## STAFF RECOMMENDATION 1504 Paris Avenue May 17, 2017

**Application:** New construction—addition and outbuilding (Detached Accessory Dwelling Unit; Setback determination)

**District:** Belmont-Hillsboro Neighborhood Conservation Zoning Overlay

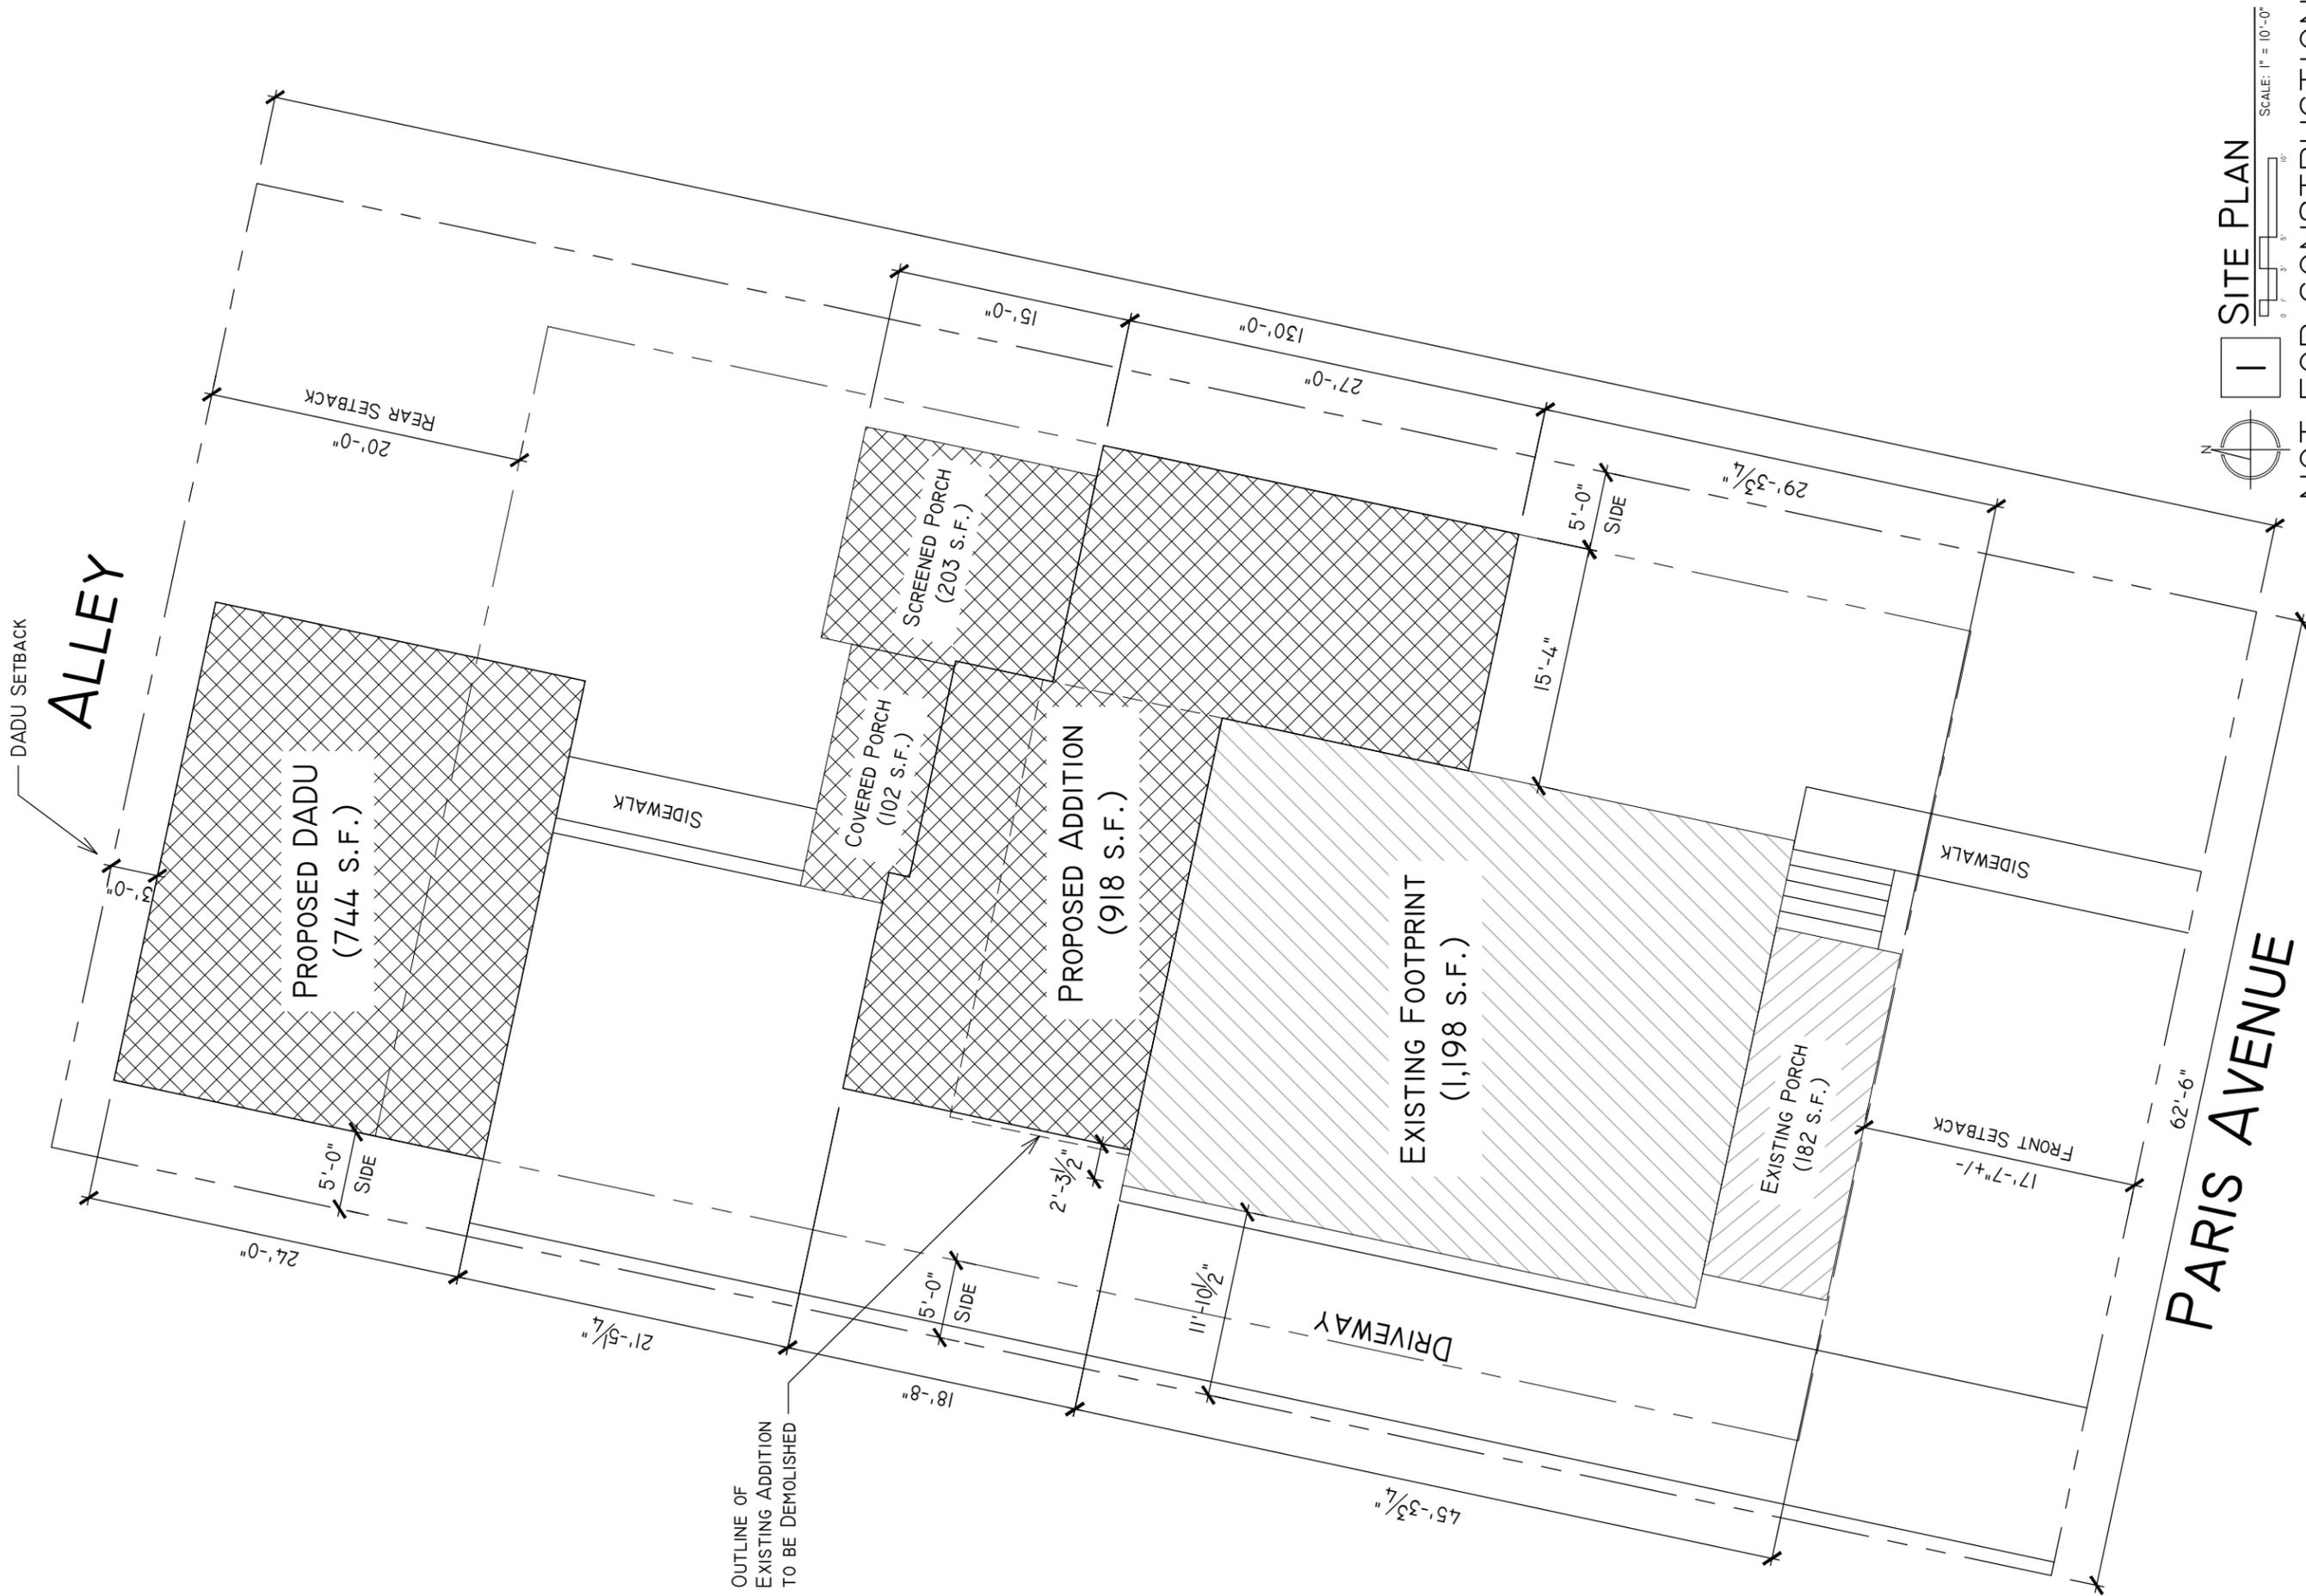
Front porch has 1/1 windows, but other windows on the house are 3/1.
